PRODUCT BULLETIN # 16746Generic Copy

Issue Date: 25-Jan-2012

TITLE: Change packing standard by removing protective band from plastic reel at ON Semiconductor (Thailand).

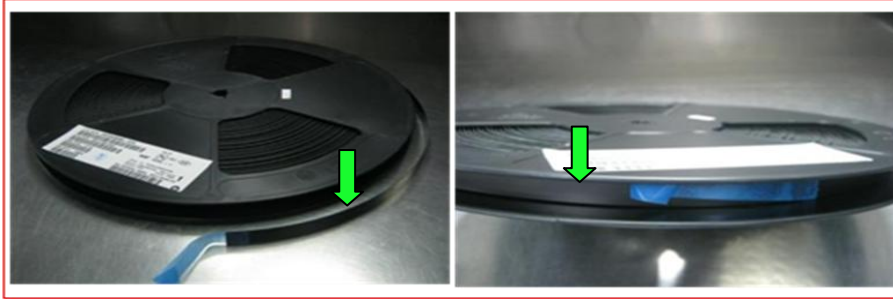
Before Change: The protective band covers the reel then closes the end by Blue ESD tape.

After Change: Blue ESD tape closes the end of the reel packing.

Reel Type	Before Change	After Change
Reel 7 inch	Protective Band 8 mm.	Blue ESD tape : Length 20 cm
Reel 13 inch	Protective Band 12 mm.	Blue ESD tape : Length 30 cm
